WHITE TAIL CROSSING BRIDGE
I-395/ROUTE 9 CONNECTOR
BREWER – EDDINGTON, ME
MEDOT
WIN 018915.50
STATE OF MAINE
MEDOT
N/A
SPECIAL PROVISION SECTION 534
PRECAST STRUCTURAL CONCRETE
WHITE TAIL CROSSING BRIDGE
SHEET 4 OF 7
N/A
CONCRETE SYSTEMS INC.
C24548

STATE OF MAINE WHITE TAIL CROSSING BRIDGE BREWER — EDDINGTON, ME			
D	CULVERT LAYOUT PLAN & SIDE ELEVATION		REV 1
	Drawing No. C24548-LO3		
Quantity: —	Project No: WIN 018915.50	SHEET 2	OF 16

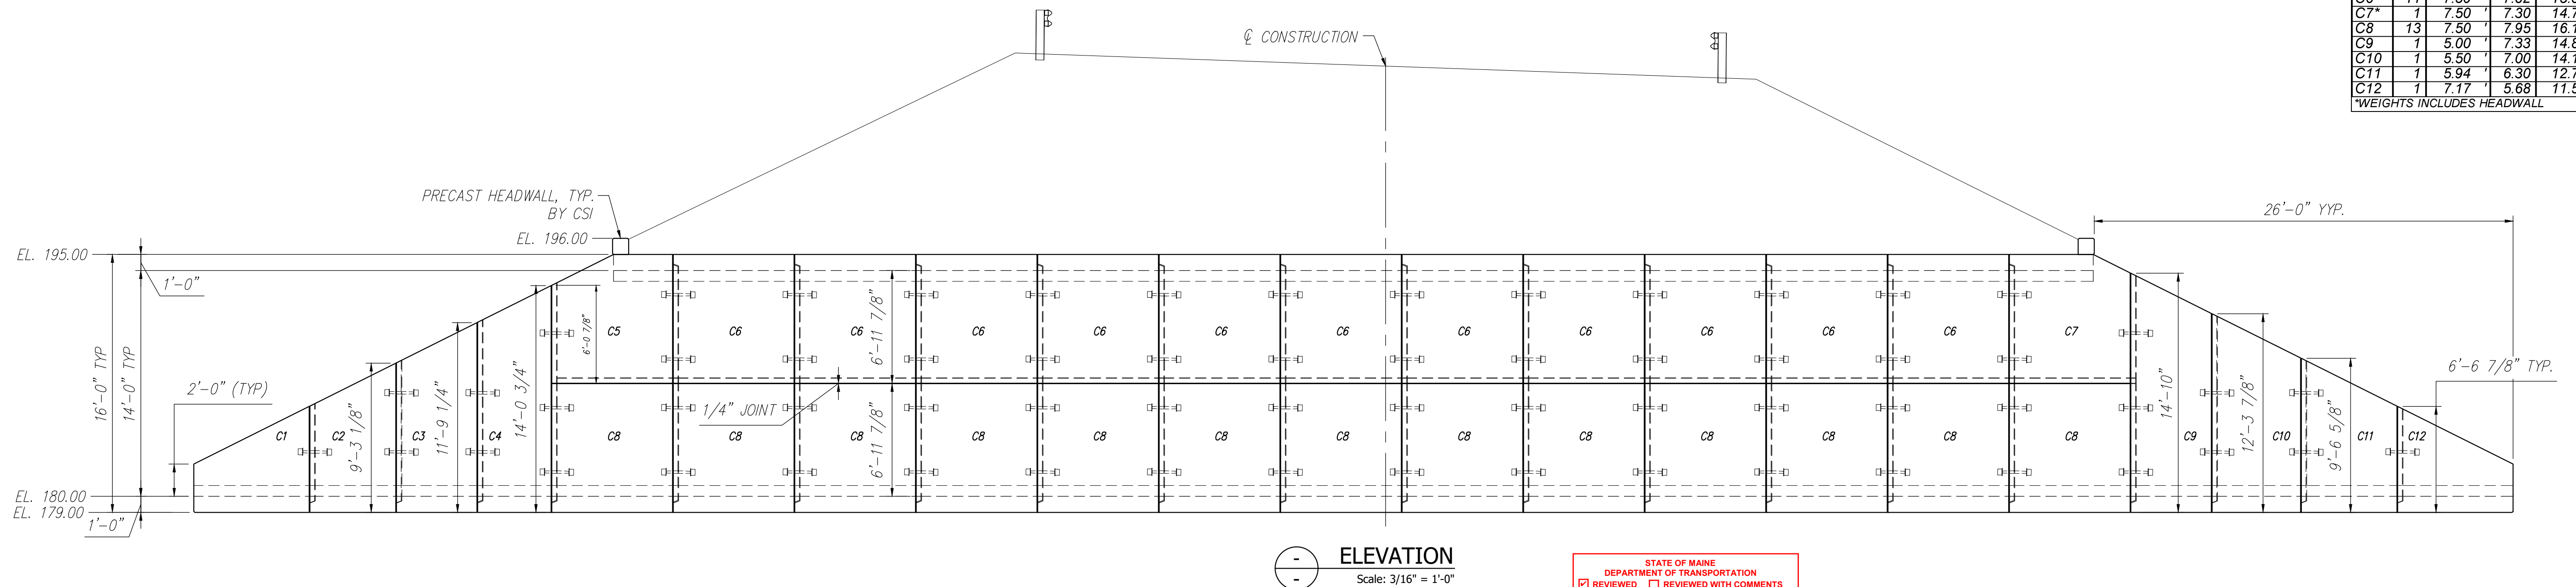
9					
	8					
	7					
	6					
	5					
	4					
	3					
	2					
	1	09/14/2021	REVISED PEICE SCHEDULE & REMOVE TOE WALLS			YAA
	Rev.	Date	DESCRIPTION			By
			REVISIONS

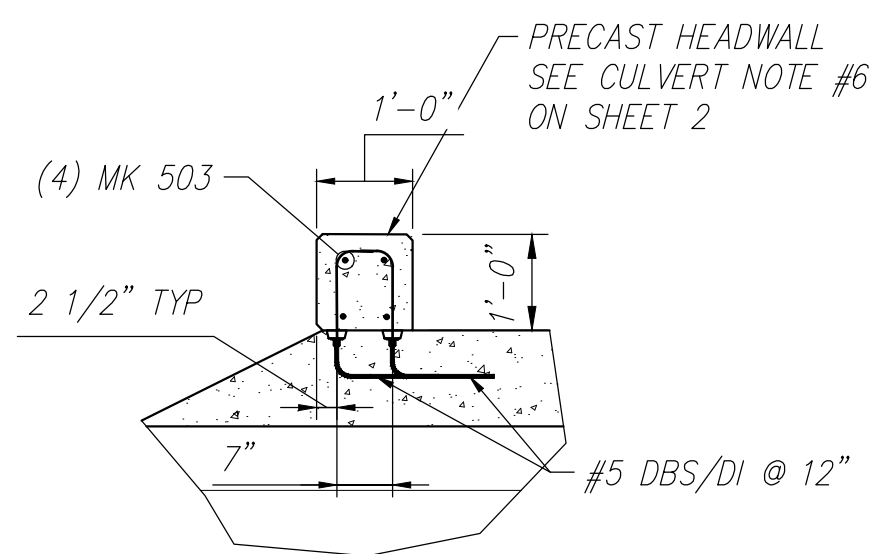
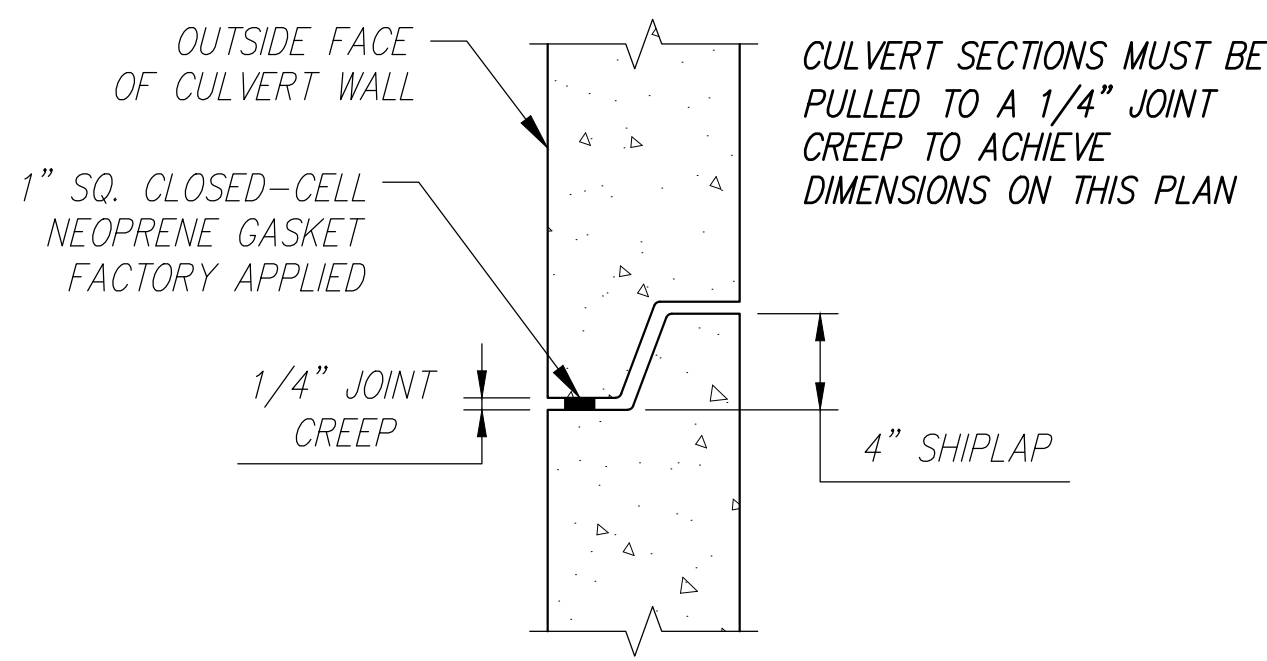
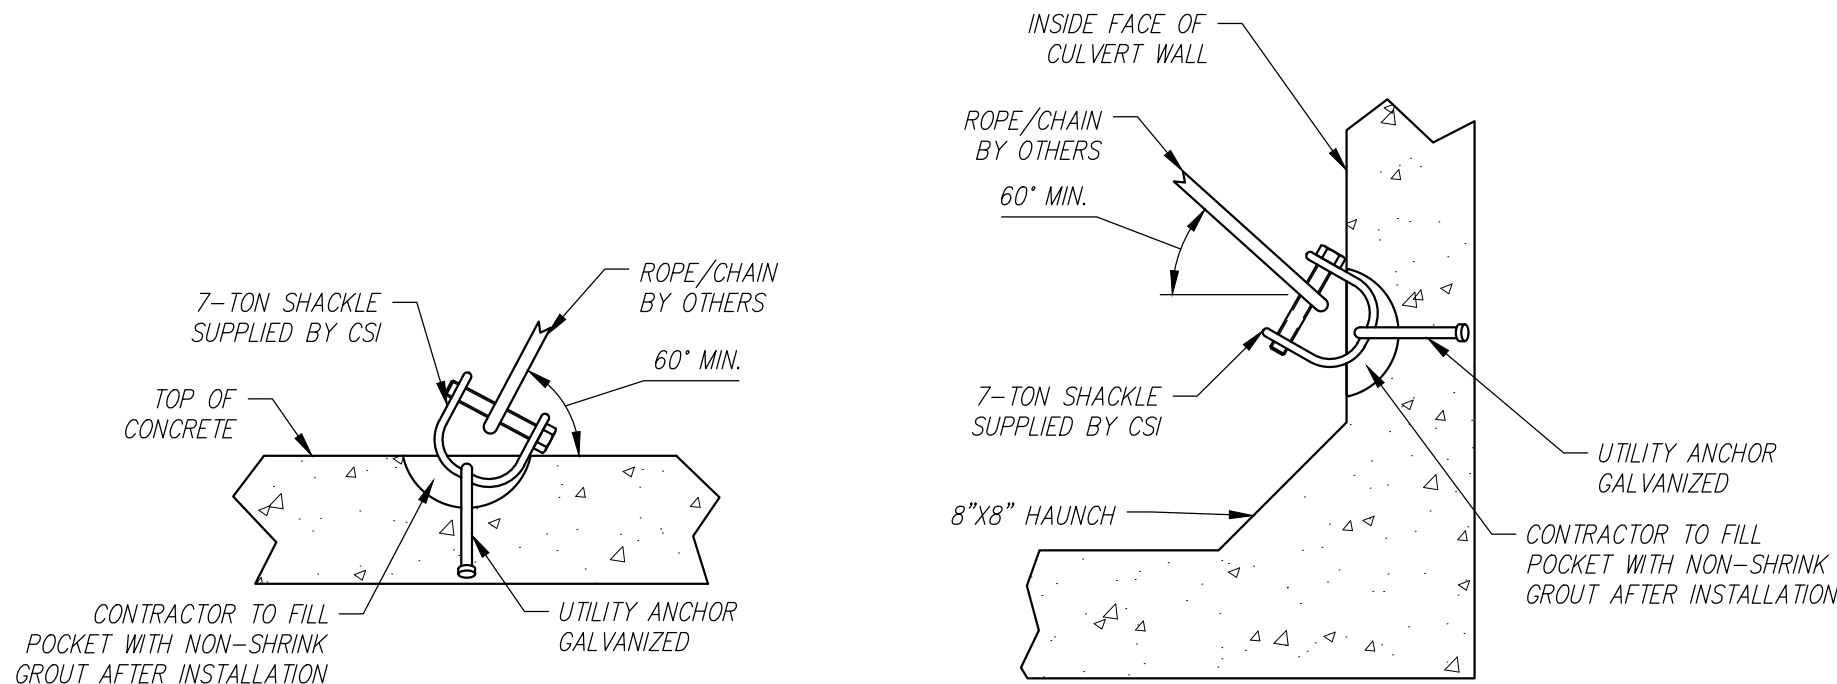
9							MEDOT		STATE OF MAINE WHITE TAIL CROSSING BRIDGE BREWER — EDDINGTON, ME							
	8							D	Drawn By YAA		Date 05/21/2021	CULVERT END ELEVATION & TYPICAL END SECTION		REV 1			
	7								Reviewed By YAA		Date 08/18/2021	Drawing No. C24548—ELE1					
	6								Approved By JAE		Date						
	5																
	4											Quantity: —		Project No: WIN 018915.50		SHEET 3 OF 16	
	3																
	2																
	1	09/14/2021	REMOVE TOE WALL DETAIL & ADD ADD'L REINFORCING AT HAUNCHES	YAA													
Rev.	Date	DESCRIPTION	By														
REVISIONS

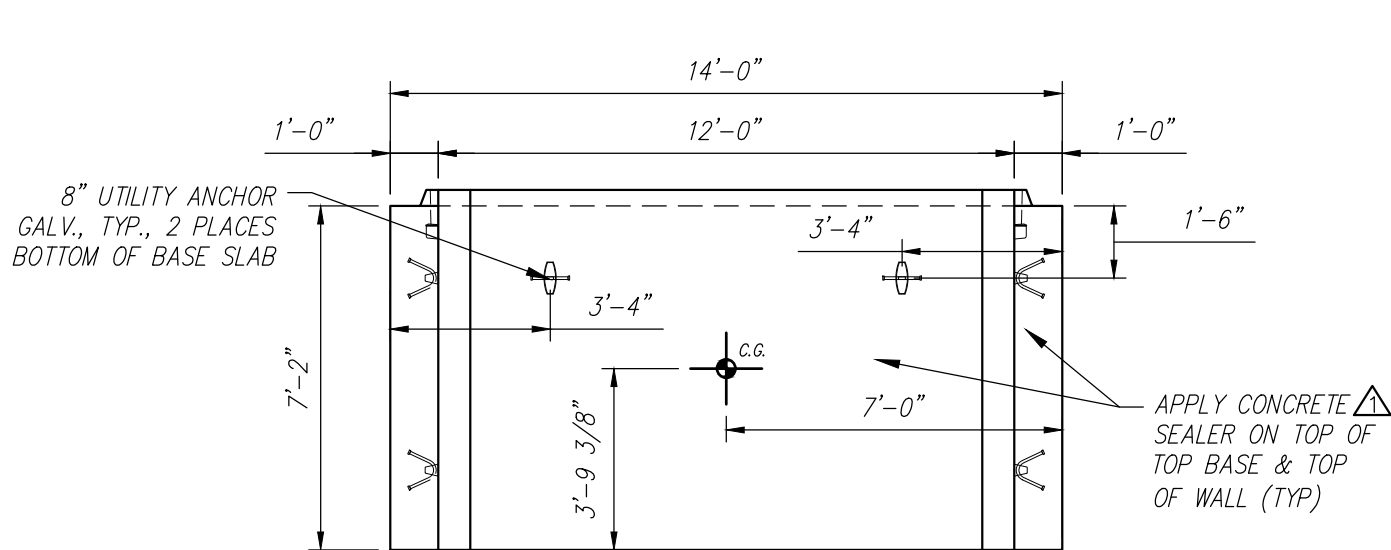
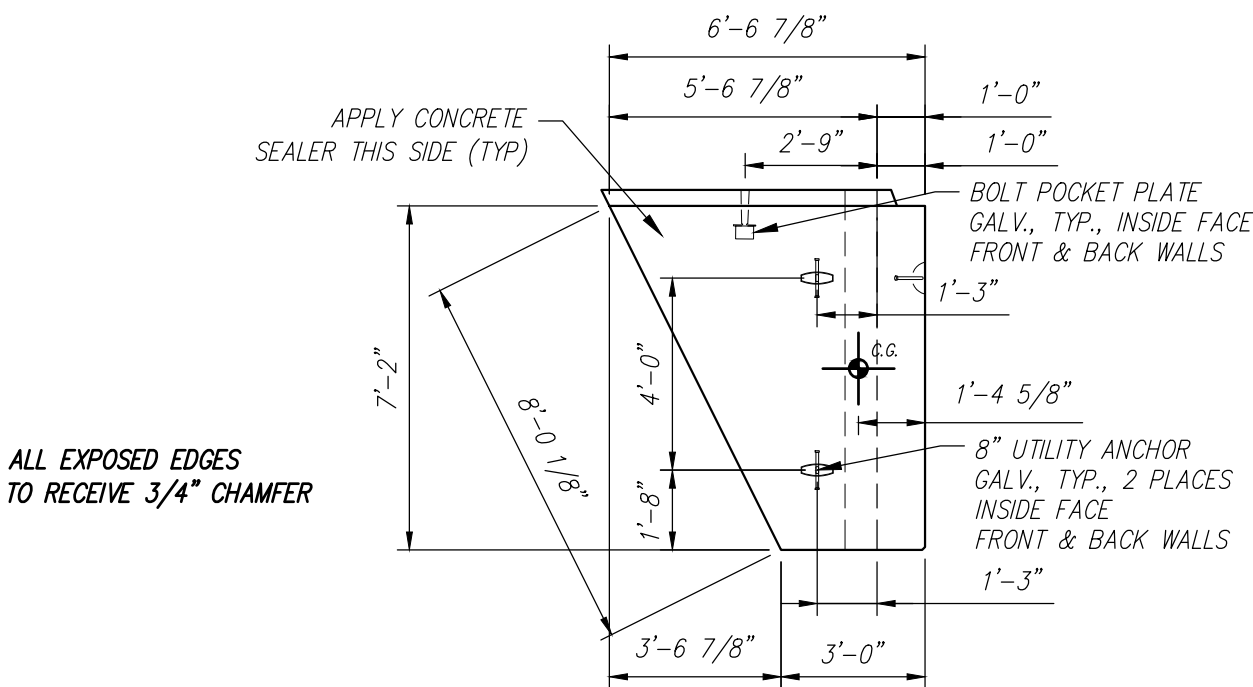
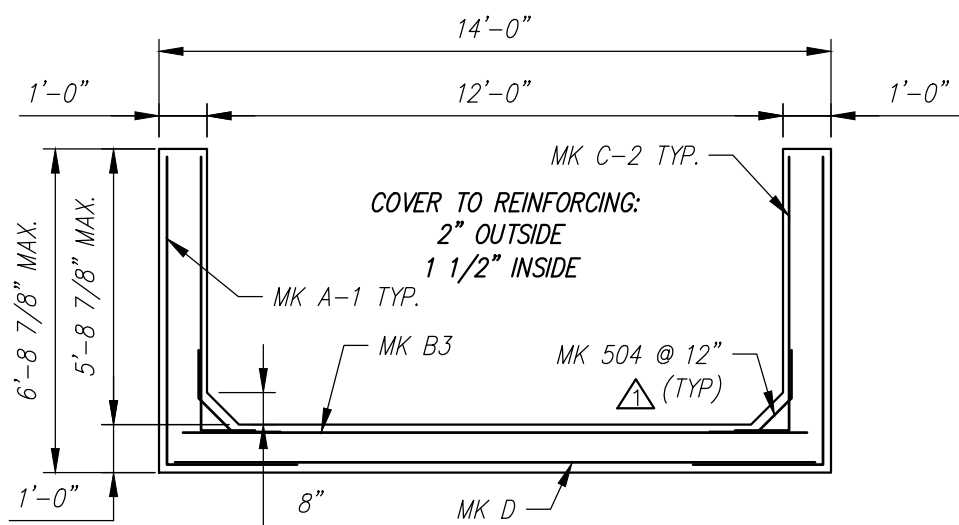
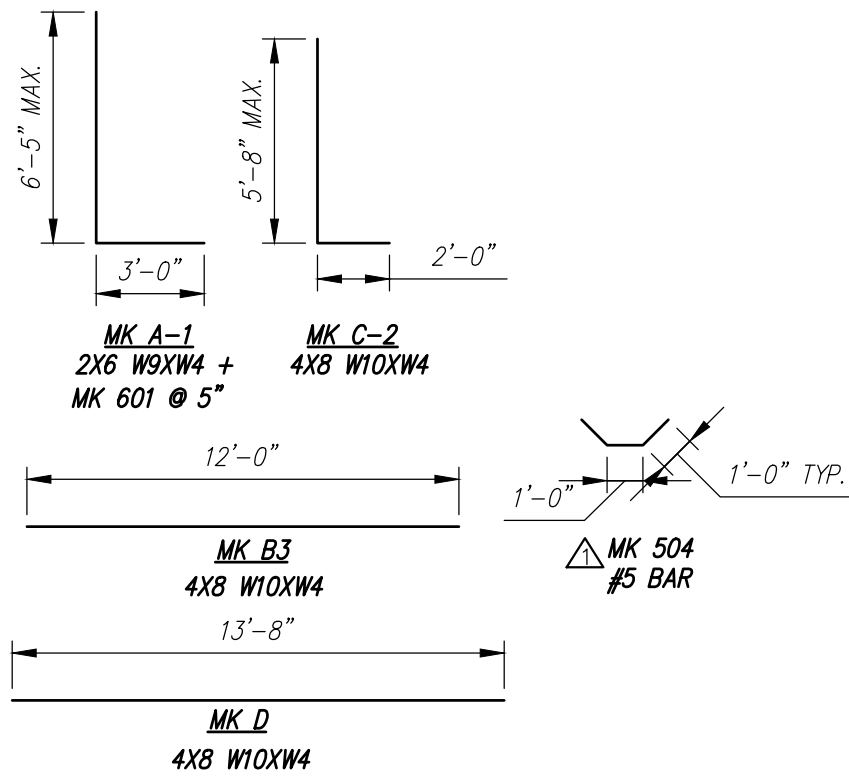
7				
		6				
		5				
		4				
		3				
		2				
		1	09/14/2021	REVISED REINFORCING & REMOVE 3"Ø HOLE IN BASE SLAB	YAA	
		Rev.	Date	DESCRIPTION	By	
				REVISIONS		
This drawing is based upon information provided from the following documents and/or sources:						
Engineer: MEDOT Project No: N/A Drawings: WHITE TAIL CROSSING BRIDGE SHEET 4 OF 7 Specifications: SPECIAL PROVISION SECTION 534 PRECAST STRUCTURAL CONCRETE Other Sources: N/A						
 Concrete Systems Inc. 9 Commercial St., Hudson, NH 03051 Phone 603-889-4163 Fax 603-889-2417		STATE AGENCY MEDOT		STATE OF MAINE WHITE TAIL CROSSING BRIDGE BREWER — EDDINGTON, ME		
Drawn By YAA Reviewed By YAA Approved By		Date 08/17/2021 Date 08/18/2021 Date		D Drawing No. INDIVIDUAL PIECE SHOP DRAWING C1 C24548—C1		
Quantity: 1		Project No: WIN 018915.50		SHEET 5 OF 16		
REV 1

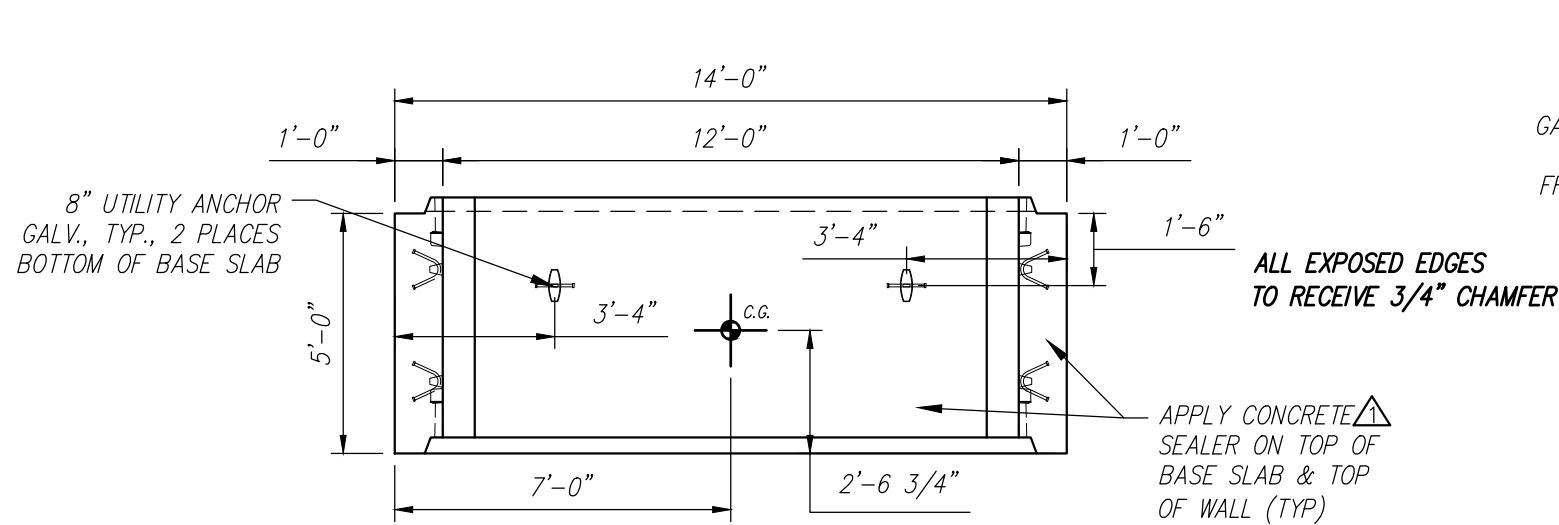
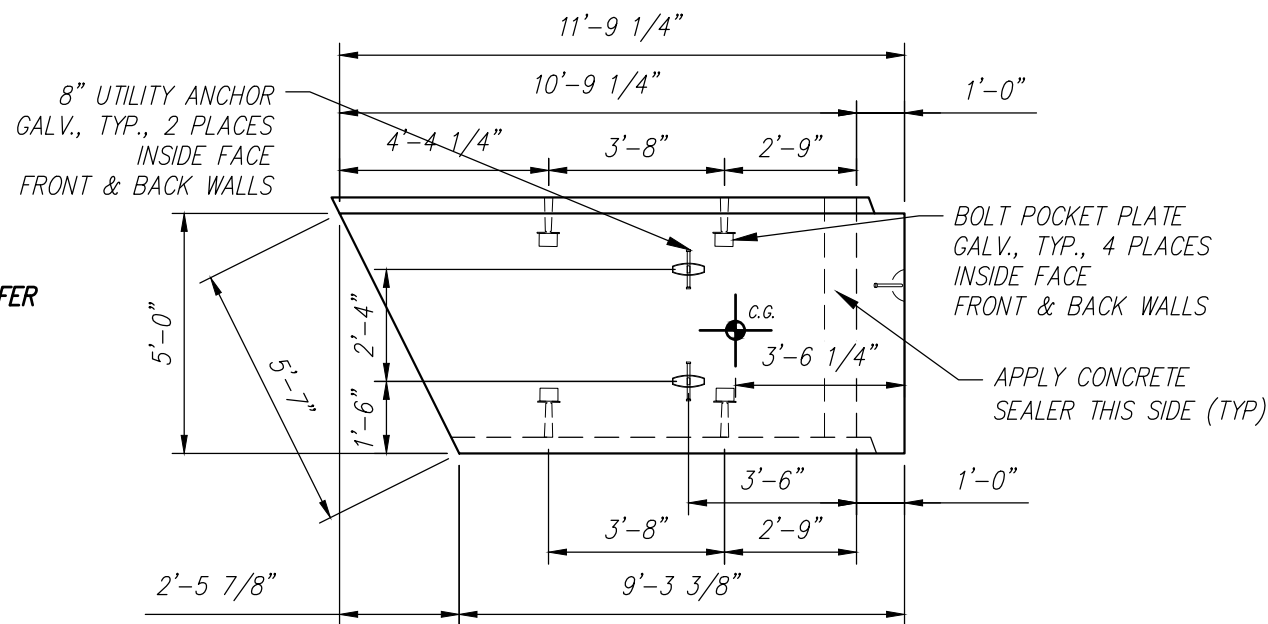
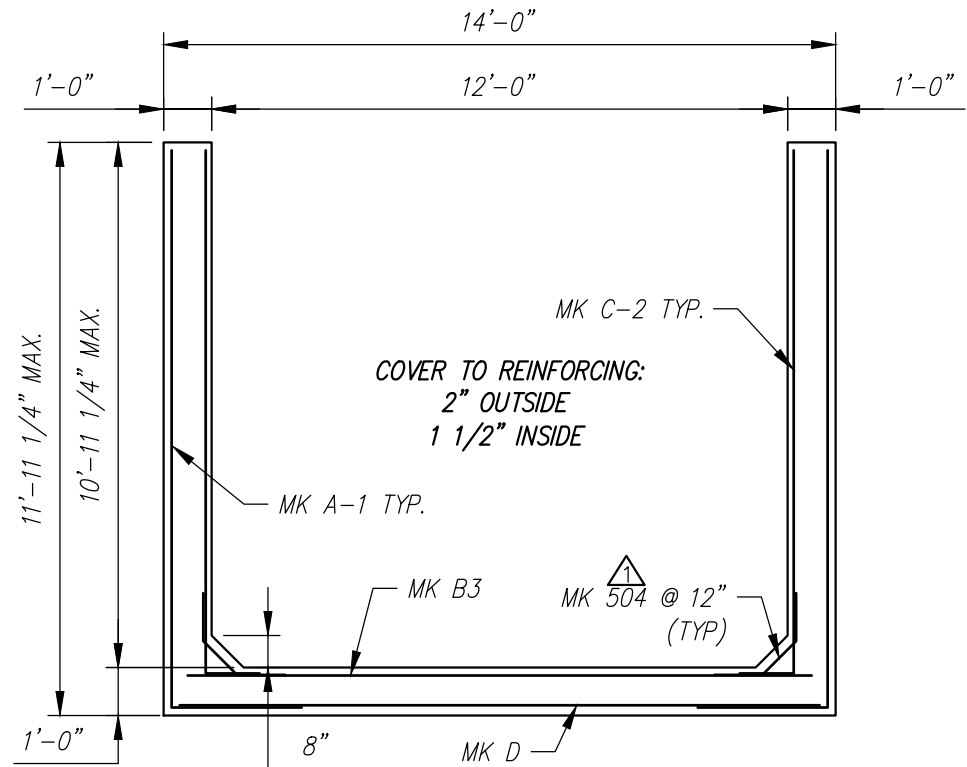
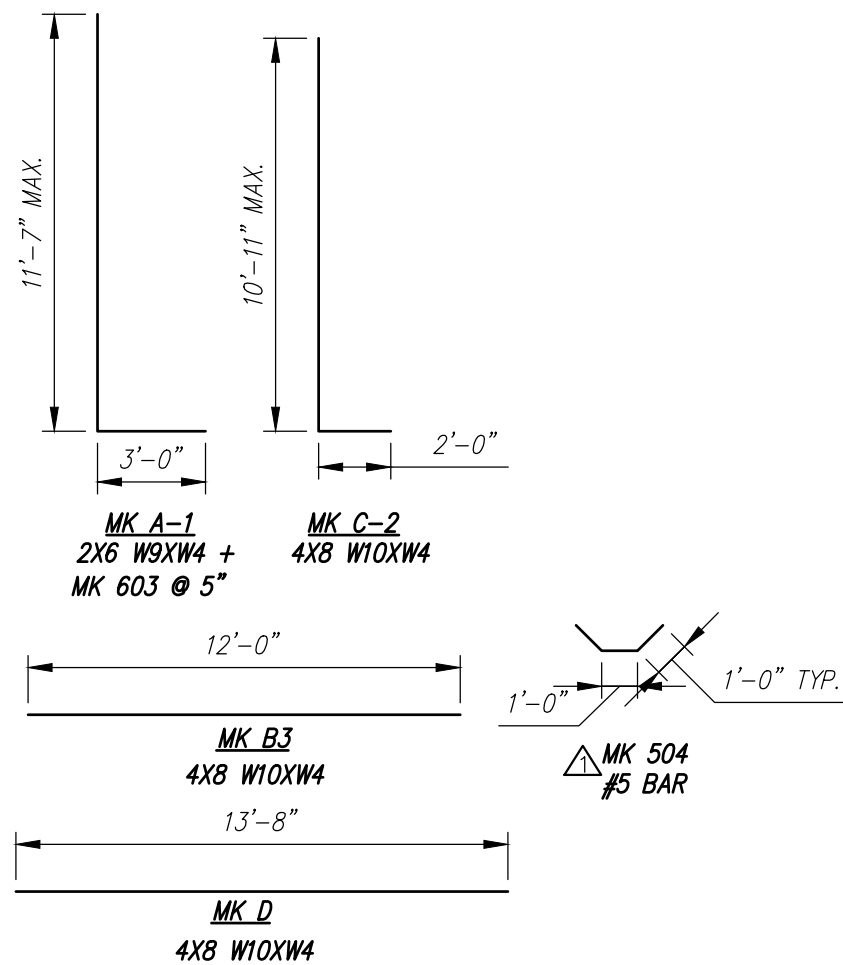
7			
		6			
		5			
		4			
		3			
		2			
		1	09/14/2021	REVISED REINFORCING	YAA
Rev.	Date		DESCRIPTION	By	
		REVISIONS			
This drawing is based upon information provided from the following documents and/or sources:					
Engineer: MEDOT Project No: N/A Drawings: WHITE TAIL CROSSING BRIDGE SHEET 4 OF 7 SPECIAL PROVISION SECTION 534 PRECAST STRUCTURAL CONCRETE Other Sources: N/A					
 Concrete Systems Inc. 9 Commercial St., Hudson, NH 03051 Phone 603-889-4163 Fax 603-889-2417					
STATE AGENCY MEDOT					
STATE OF MAINE WHITE TAIL CROSSING BRIDGE BREWER - EDDINGTON, ME					
INDIVIDUAL PIECE SHOP DRAWING C3					
C24548-C3					
Quantity: 1 Project No: WIN 018915.50 SHEET 7 OF 16
